SHOPS @ MCLAUGHLIN II PEYTON, CO FINAL LANDSCAPE PLAN	THIS PLAN SHALL NOT BE COPIED WITHOUT THE PERMISSION OF NDS, INC.	VATURAL DESIGN SOLUTIONS Landscape Architecture	Land Planning · Irrigation Design 5539 Colt Drive, Longmont, CO 80503 (303) 443-0388 · neil@ndscolorado.com
SHOPS			PLAZ PLAZ
	@ MCLAL	PEYTON, CO	INAL L

Markup Summary

SEASONS.

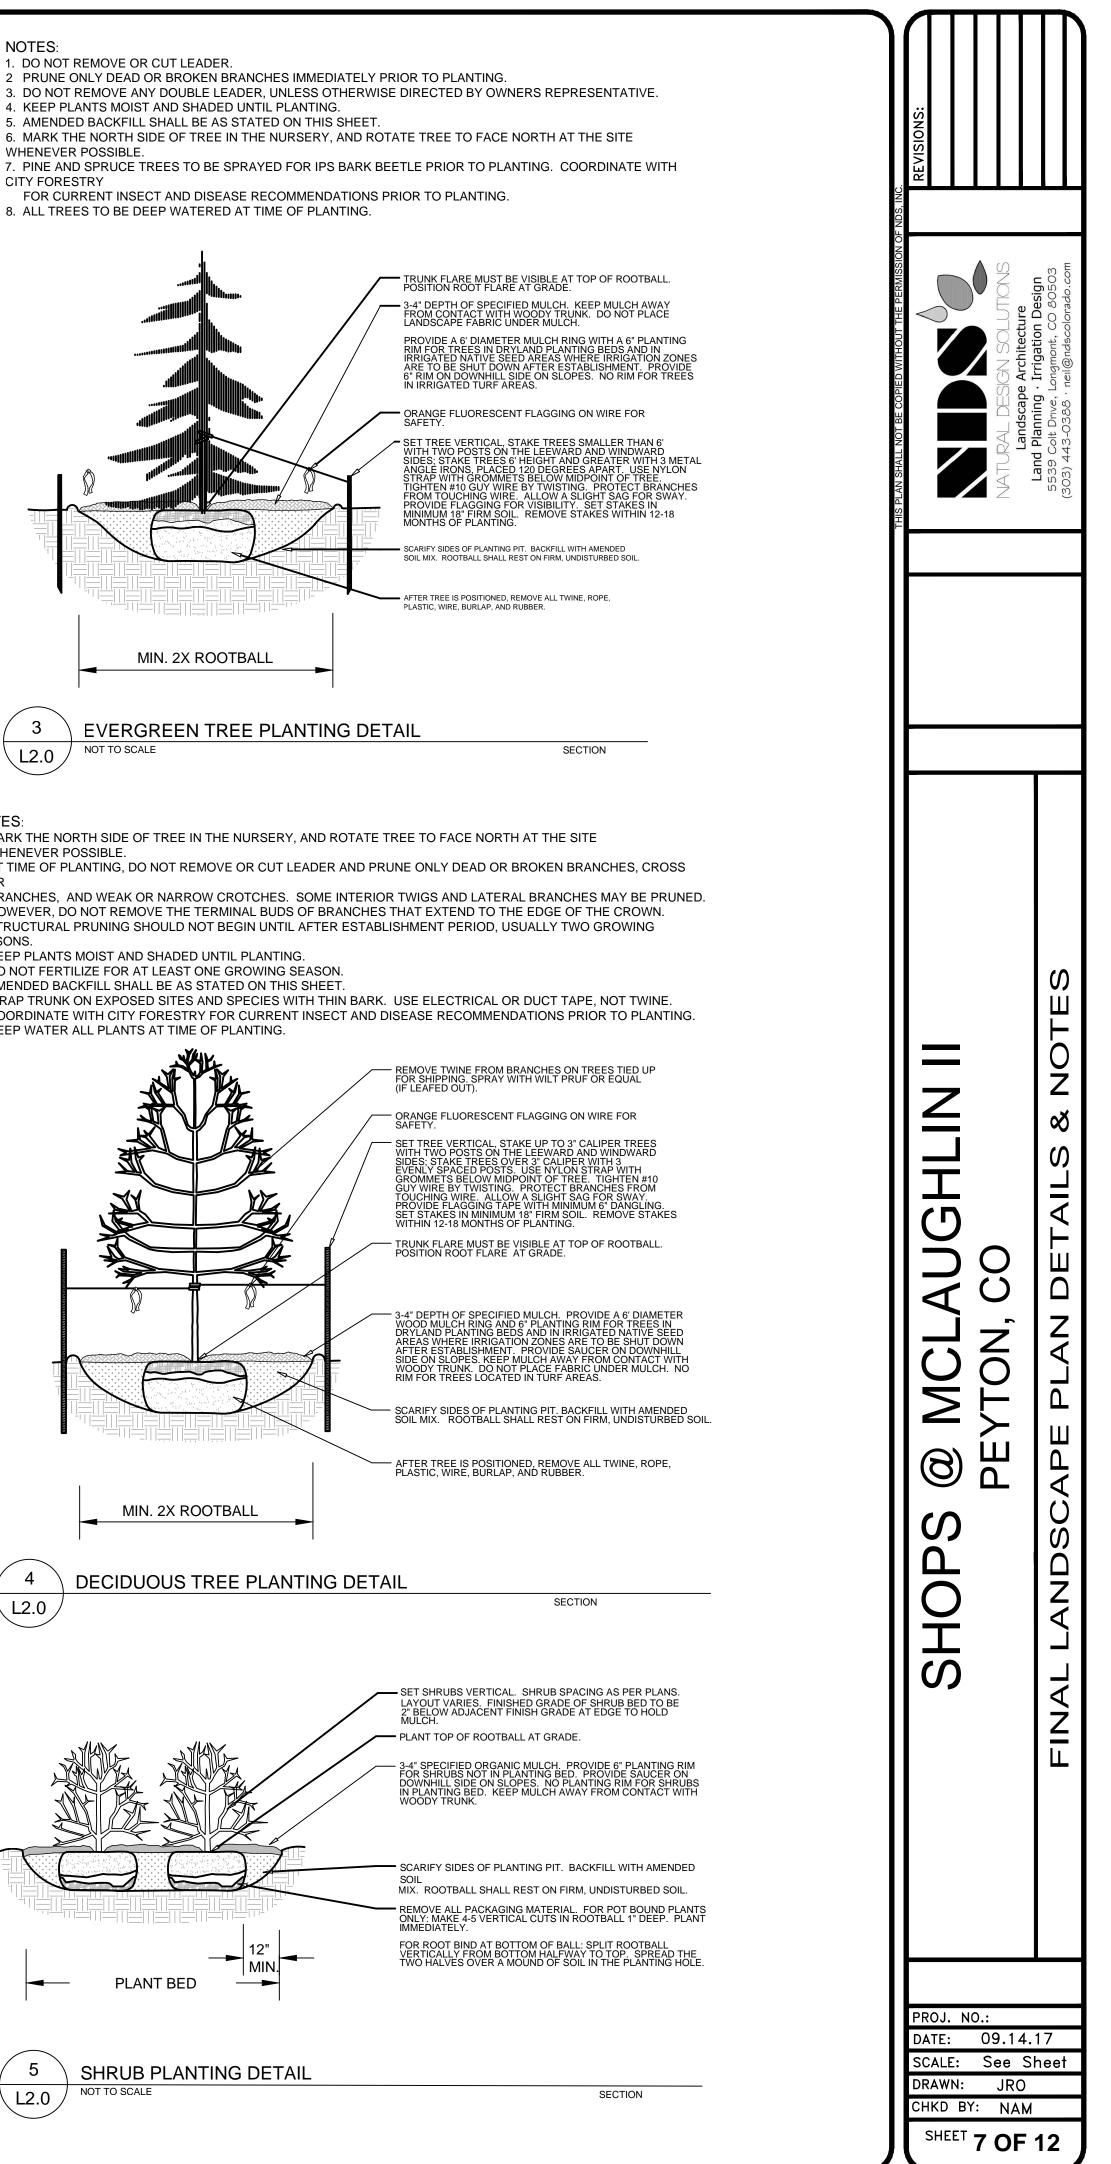
rock/mulch along roadways to minimize water usage and potential maintenance issues

Staff supports utilizing
